RFI

RFI #: 161
Date: 6/25/2012
Job: EB-02 Keller Springs Lofts
Phone: 877-777-5115

Subject: Electrical Outlets Moved for Code

KELLER SPRINGS LOFTS
LOFT APARTMENTS IN ADOBEK TEXAS
E-22
REVISED 6/20
JOB NO. EB-02-11
DATE 6/25/12

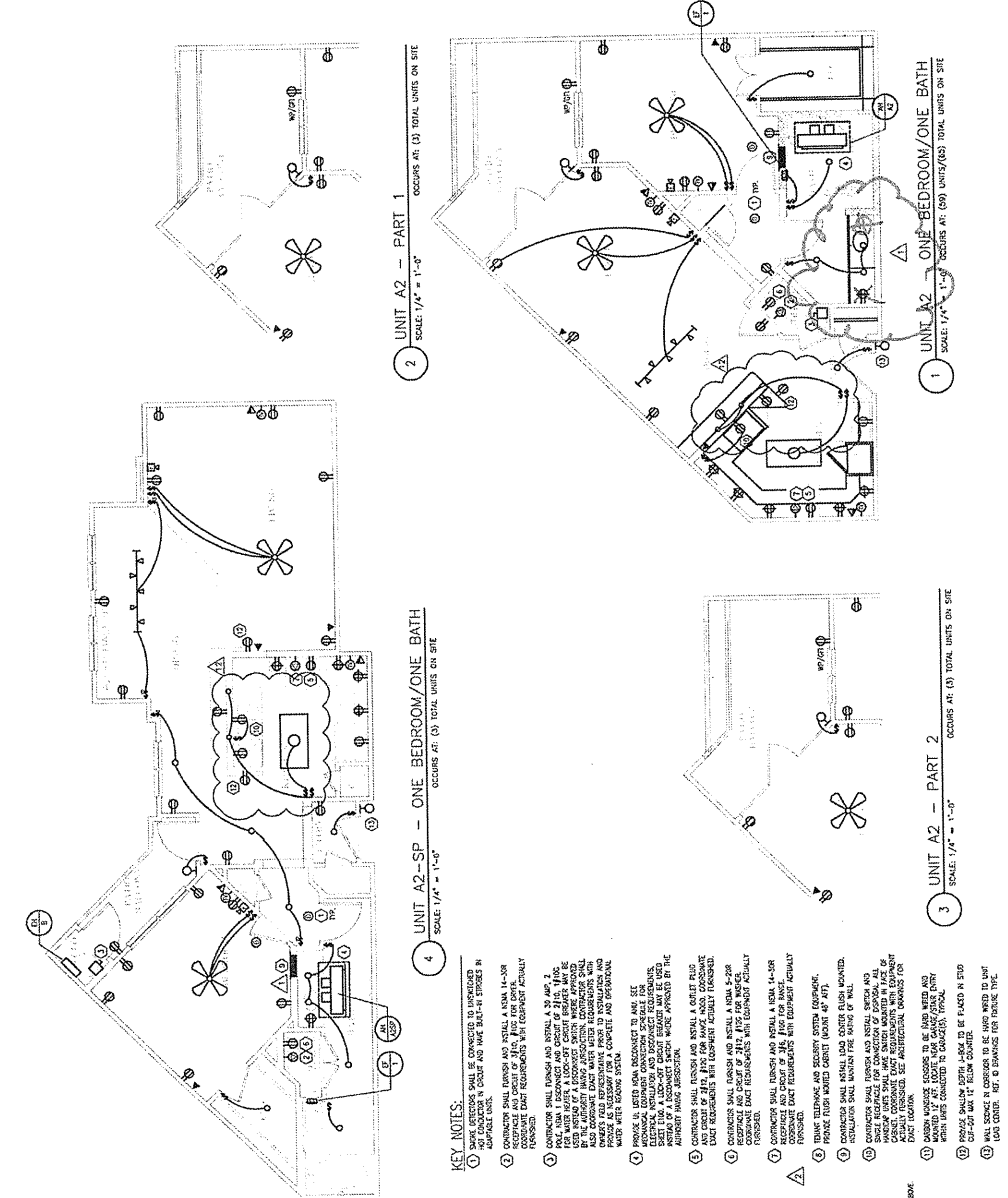
Request: We had an issue at another job where some receptacles needed to be moved in bathrooms due to code. Please check and see if this issue will need to be addressed at this job and revise plans if needed. **Date Required:** 6/26/2012

Reference the attached pdf's showing the correct outlet locations.

- 1. RECEPTACLE TO BE MOVED TO THIS LOCATION
- 2. RECEPTACLE TO BE MOVED TO THIS LOCATION
- 3. RECEPTACLE TO BE MOVED TO THIS LOCATION
- 4. RECEPTACLE TO BE MOVED TO THIS LOCATION

- 5. RECEPTACLE TO BE MOVED TO THIS LOCATION
- 6. RECEPTACLE TO BE MOVED TO THIS LOCATION
- 7. RECEPTACLE TO BE MOVED TO THIS LOCATION
- 8. RECEPTACLE TO BE MOVED TO THIS LOCATION

- 9. RECEPTACLE TO BE MOVED TO THIS LOCATION
- 10. RECEPTACLE TO BE MOVED TO THIS LOCATION
- 11. RECEPTACLE TO BE MOVED TO THIS LOCATION
- 12. RECEPTACLE TO BE MOVED TO THIS LOCATION

- 13. RECEPTACLE TO BE MOVED TO THIS LOCATION
- 14. RECEPTACLE TO BE MOVED TO THIS LOCATION
- 15. RECEPTACLE TO BE MOVED TO THIS LOCATION
- 16. RECEPTACLE TO BE MOVED TO THIS LOCATION

- 17. RECEPTACLE TO BE MOVED TO THIS LOCATION
- 18. RECEPTACLE TO BE MOVED TO THIS LOCATION
- 19. RECEPTACLE TO BE MOVED TO THIS LOCATION
- 20. RECEPTACLE TO BE MOVED TO THIS LOCATION
